Donald Kussbaumer, Chief  
Source and Special Nuclear Materials Branch

Chris Beck, Staff Engineer - Structural

UNITED NUCLEAR (HEMATITE), DOCKET 70-36, NOVEMBER 17, 1961

## Suggested Improved Clamp Design

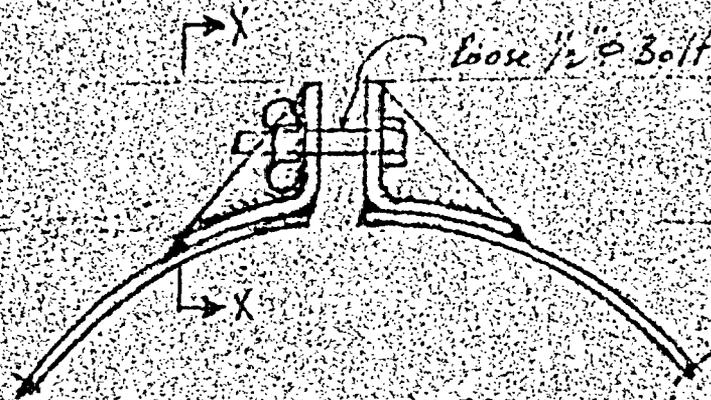
- c. The real weak part of the whole assembly is the clamp design. An impact force of less than 3 G's (in terms of the loaded drum) would tend to open up the flanged clamp. It is expected that due to a slightly higher impact force the strap would slip away from the wing-nut causing the drum to fly out of its hold. It is suggested that the design be improved and greatly strengthened.

# Acceleration vs P.R. Impact Speed Curve (up to 16 M/hr.)

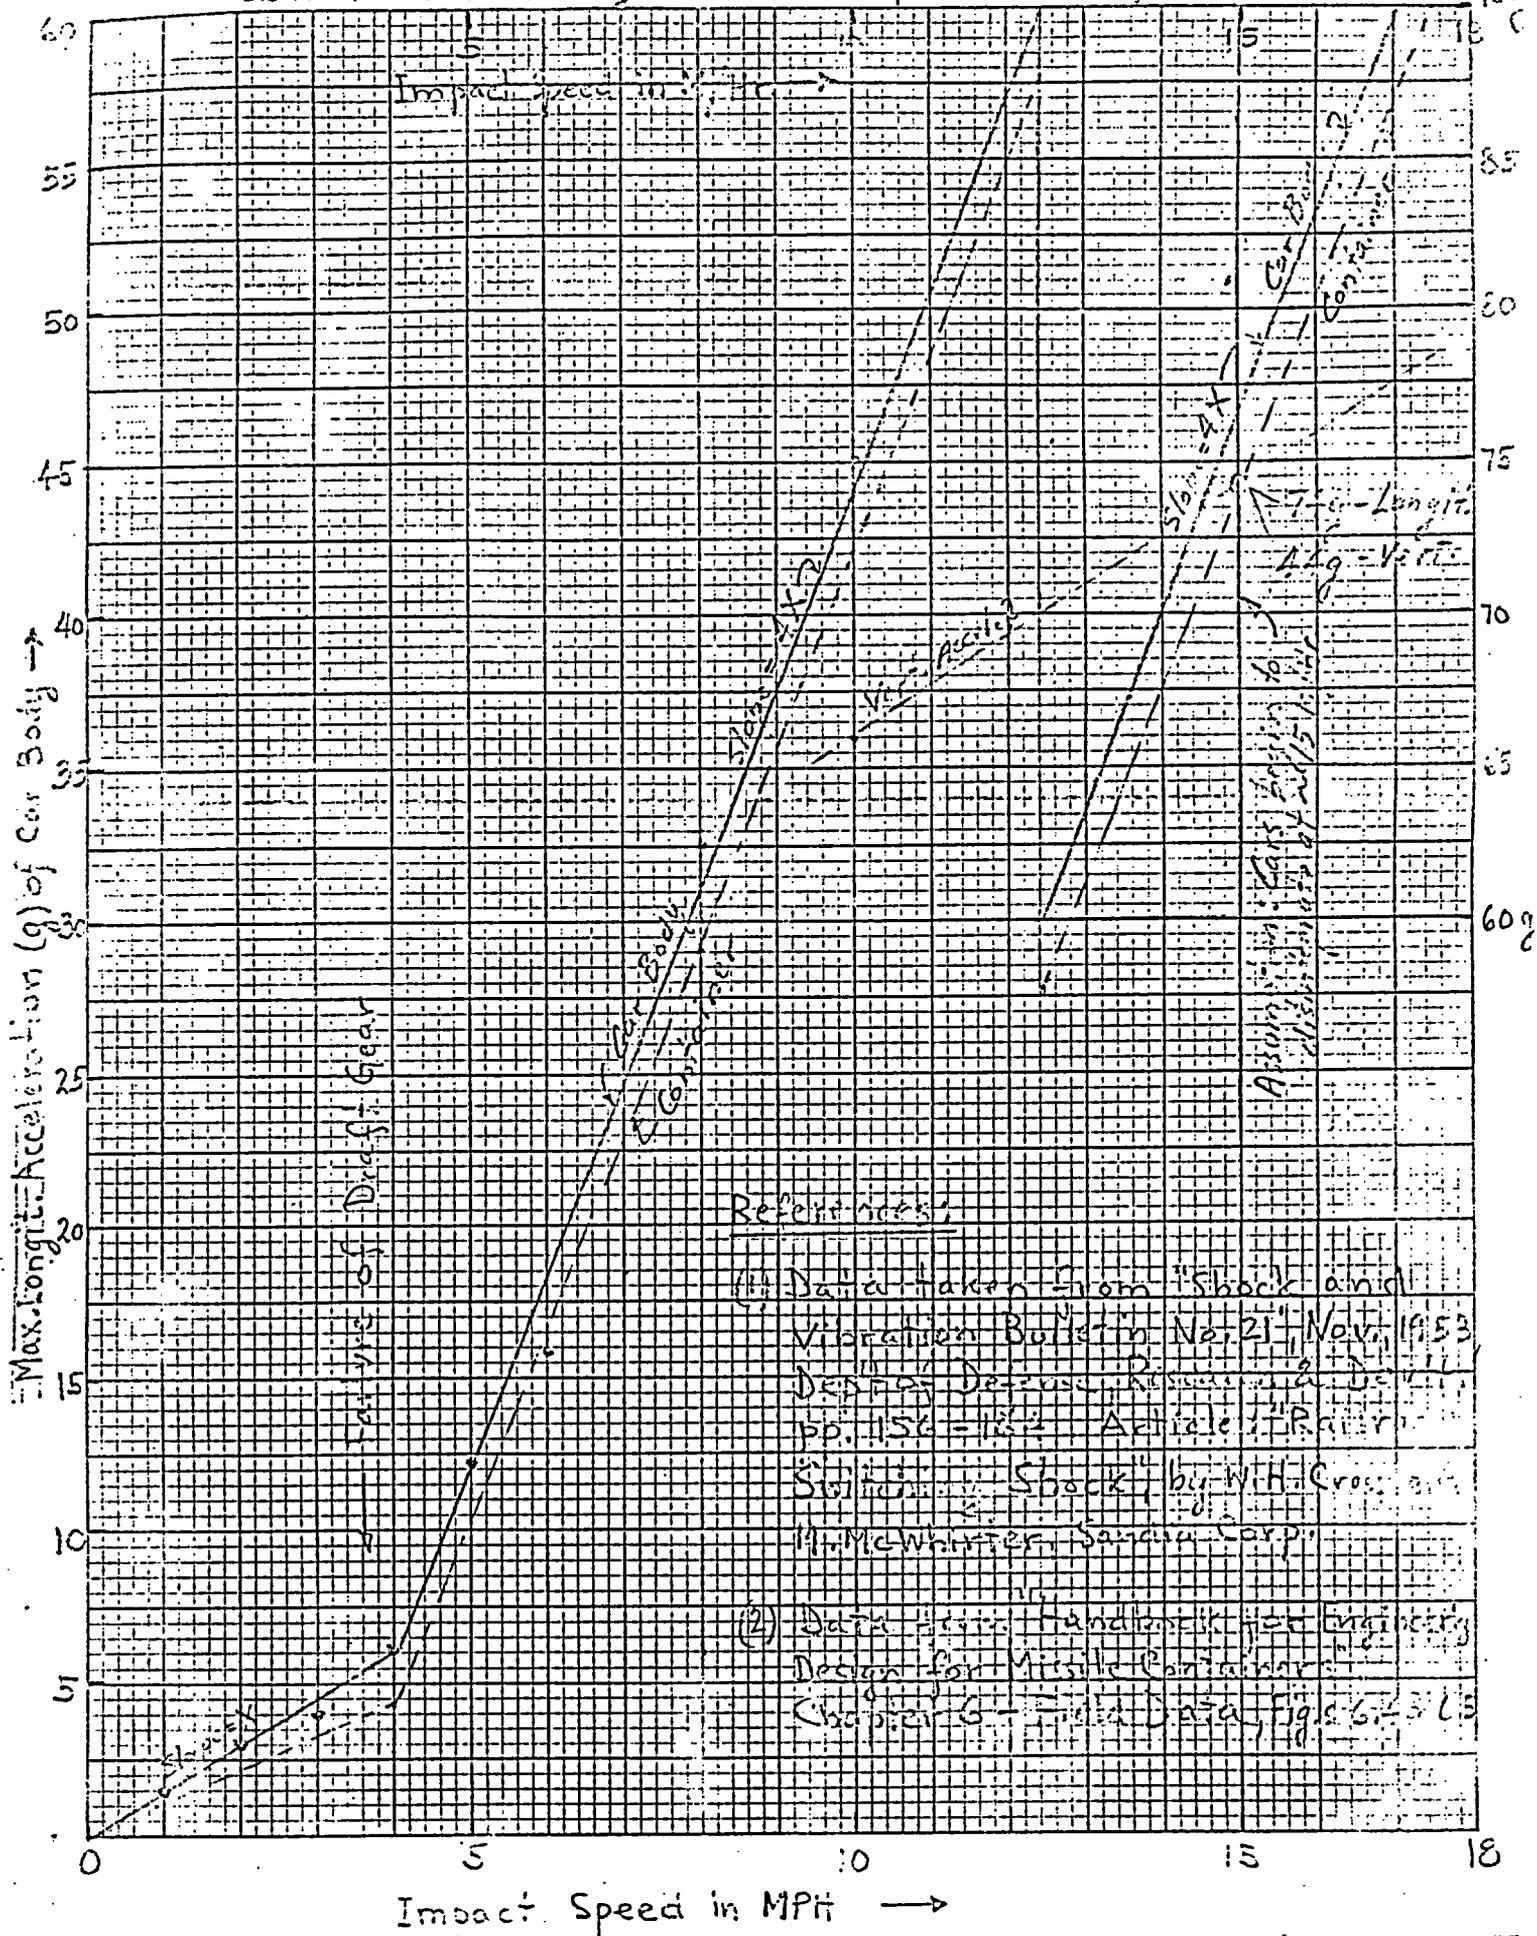
We have reviewed the proposed shipping container for structural integrity. Unfortunately, there are no firm regulations to follow, such as Part 72 for shipment of irradiated fuel elements. The Bureau of Explosives' requirements (File No. 25-16-17h, Revised Sept. 1, 1960) are not very specific; however, they specify that the container "must be so designed that it will maintain its efficiency even if subject to the effects of rather severe fire or impact". It is generally believed that railroad switching operations in classification yards cause the most severe damage to lading during rail shipment. Instrumented switching speed observations collected from a representative number of classification-yard operations indicated a mean impact velocity of 7 mph and a maximum as high as 10 mph. The corresponding impact forces on the container may be assumed, based on attached chart, to be about 23 G's and 35G's respectively for the 7 and 10 mph impact speeds. It is suggested that an impact force of 30 G's be used in analyzing the important elements of these types of containers to insure required safety during shipment.
